CONTRACT ADDENDUM

ADDENDA NO.: 002

Revised Bid Proposal Form for Addenda 2 - Dalton Project No. PW-2021-COVIE COVIE RIDGE REGIONAL DETENTION POND & STORMWATER IMPROVEMENTS PROJECT

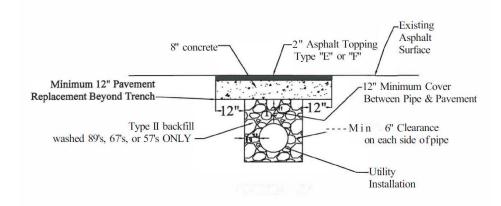
- 4. There are no construction easements along Winton Drive, only the existing ROW. As the construction nears structure A4 the edge of the edge of pipe is only 2 feet from the edge of the right of way. Will a construction easement be obtained along Winton Drive beyond the right of way so the contractor is prevented from encroaching on private property while performing the work? The footprint of the construction equipment will likely be wider than the area available not even considering any working room. The City has already obtained a temporary construction easement from the private property owners that will be affected. See easement drawing attached.
- 5. The bid form has a pay item for Foundation Backfill Material. Where will this be used? Winton Drive trench repairs, please refer to trench repair detail below.

- 6. The bid form has a pay item for Class B Concrete. Where will this be used? Winton Drive trench repair, please see detail in answer to question 5 above.
